Coal Creek Village PUD

Requested Waivers

From the Highway 42 Revitalization Area Framework Plan

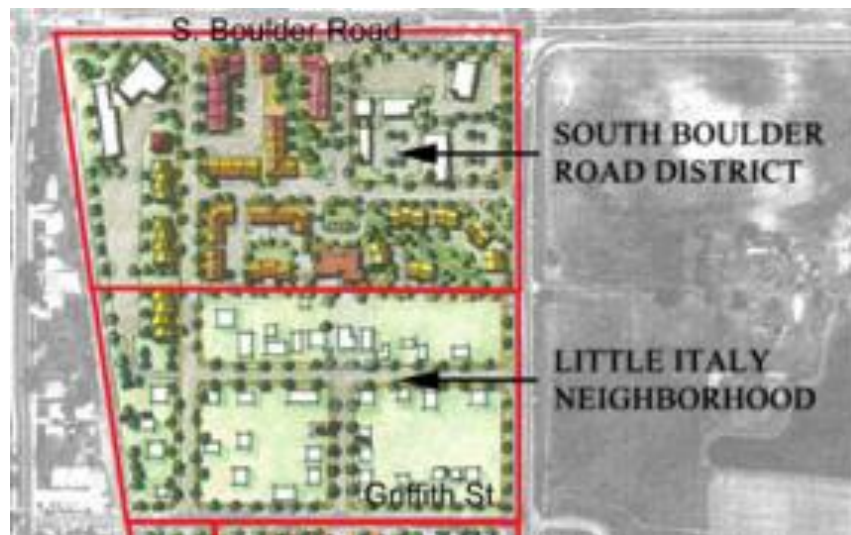
Waiver Number 1

Requirement: MUDDSG 1.3.A.1 East and west sides of blocks to be 270-320 feet.
MUDDSG 1.3.B.1 North and south sides of blocks to be 300-400 feet.

Proposed:	Block One	<u>East and west sides 146 feet</u>
		<u>North and south sides 321 feet</u>
	Block Two	<u>East and west sides 293 feet</u>
		<u>North and south sides 333 feet</u>
	Block Three	<u>East and west sides 443 feet</u>
		<u>North and South side 155 feet</u>
	Block Four	<u>East and west sides 221 feet</u>
		<u>North and south sides 295 feet</u>
	Block Five	<u>East and west sides 332 feet</u>
		<u>North and south sides 246 feet</u>

The street layout and resulting block sizes are largely determined by existing access points along South Boulder Road and Highway 42. In addition, the Front Street alignment connecting to the south is consistent with the Highway 42 Revitalization Area Framework Plan depicted above. The fact that the site is bordered by the Colorado and Southern Railroad on the west further puts limitations on block size.

While not all the specific block dimensions are consistent with requirements, the street layout and blocks do meet the intent of the MUDDSG. Traffic is dispersed and distributed in a logical fashion consistent with the Highway 42 Framework Plan shown above. The site plan proposes sidewalks and tree lawns along all public streets and provides for safe, convenient and attractive pedestrian connections throughout.

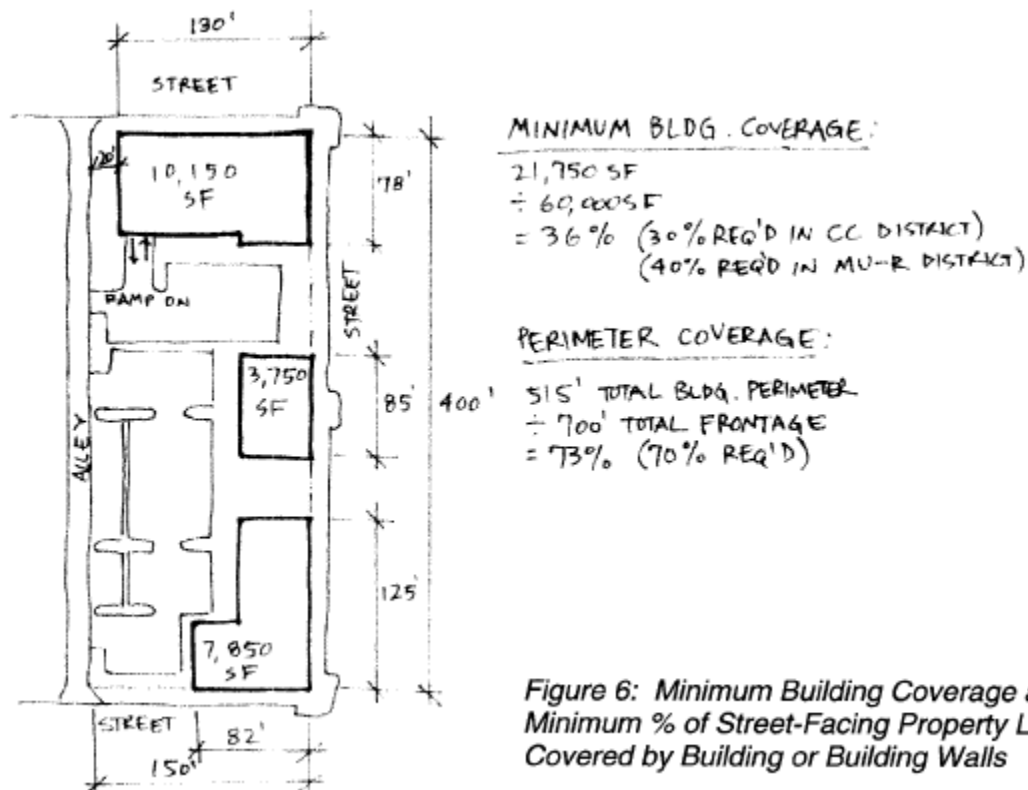
Waiver Number 5

Requirement: Minimum Building Coverage 40%

Proposed: 21.2%

The dimensional and bulk standards are intended to encourage and allow more "urban scale" development within the Highway 42 Revitalization Area consistent with planning goals for that area. Compared to other commercial and residential development allowed in Louisville, "urban scale" generally means taller buildings like those found in downtown Louisville, greater lot coverage, and buildings pushed close to the front property line.

We believe that Coal Creek Village PUD accomplishes the intent of the standard. Most of the buildings in the development are 3-stories tall and are brought close to the front property line with parking enclosed in garages or located to the back side. However, it's hard to imagine how the proposed project could achieve 40% building coverage without providing structured parking. Figure 6 (below) was provided to help clarify the standard. The example illustrates 1-story buildings, and it only achieves 36% coverage. The proposed mixed-use buildings (3 & 4) and the multi-family buildings (1&2) are 3-story buildings and require more parking than a 1-story building would. Additional parking means more circulation drives and the additional pavement requires additional stormwater detention. The overall residential density of 16.5 DU/AC necessitates the need for additional site amenities, parks and open space. Additionally, Figure 6 alludes to the use of structured parking to help achieve the standard – but the cost to construct structured parking is so great that the use of structured parking would remove the middle-class attainability aspect of the proposed development. Given the nature of the proposed mixed-use project, we believe achieving 40% lot coverage is not necessary nor practical as demonstrated by Figure 6.
